Product Change Notice

PCN Ref Nº: PT-15 V with improved (flanged) collector

New flange close up

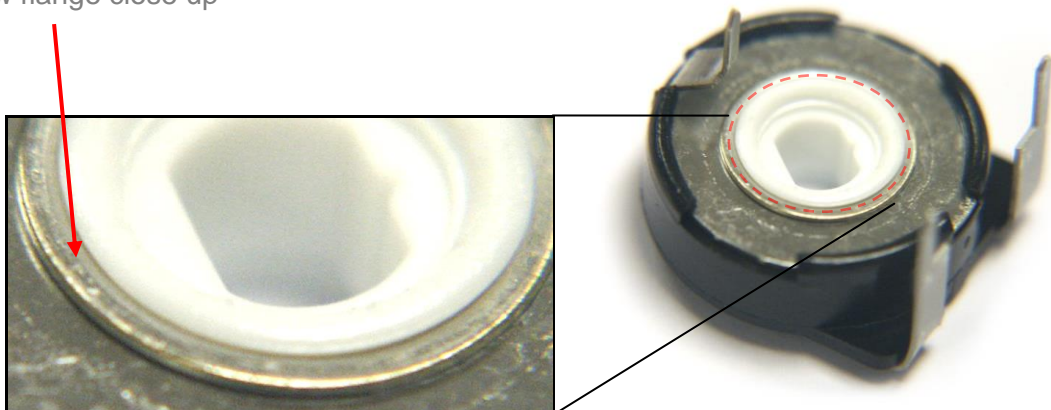
The collector for the PT-15 V model has been redesigned to include a flange near the rotor's hole. This change affords significant improvements in terms of rotational feeling and improved torque & hysteresis. All other product's specifications remain unaffected.

REASONS FOR CHANGE: Improved rotational feeling. More homogeneous torque. Improved hysteresis.
